Proposed Changes to IEEE Std 802.3, Sub-clauses 25.4.5 and 25.4.7, to address the need for reduced Open Circuit Inductance in Ethernet Magnetics

August 2011

Figure 25-1—Type 2 system time constant test circuit

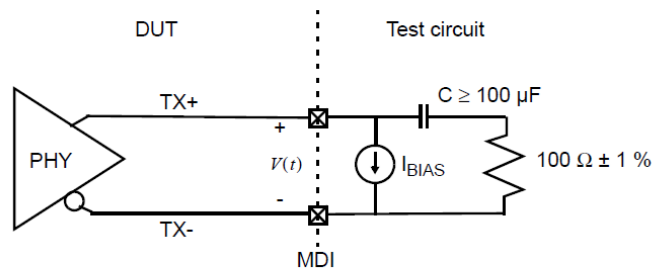
2. Delete the word 'Type 2' in title for Figure 25-1 and 25-2 in section 25.4.5.1 Equivalent system time constant.
3. Change sub-clause 25.4.7:

4. Change the Note for Figure 25-1 in section 25.4.5.1

NOTE-For transmitters in a Type 1 or Type 2 PSE or PD, I_{BIAS} is the current $I_{unb} / 2$ defined in Clause 33. For transmitters not in a Type 1 or Type 2 PSE or PD, I_{BIAS} is not required.
